2016/06/01

### MVMA-260/300、MVMB-220/300、MVHD-220 Series Rear Cover Exterior、Color and Screw Change Notification

###### A. MVMB/MVHD-220 Series

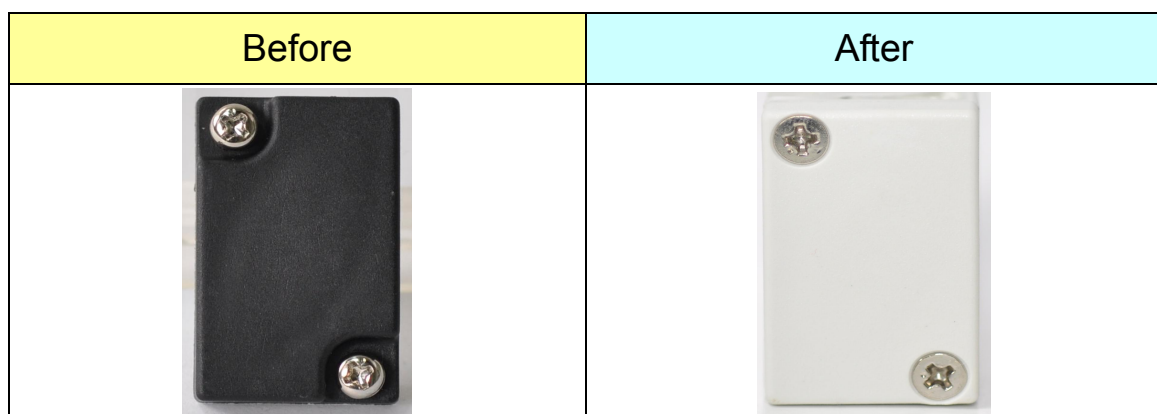
##### 3.2 Rear cover exterior and color change :
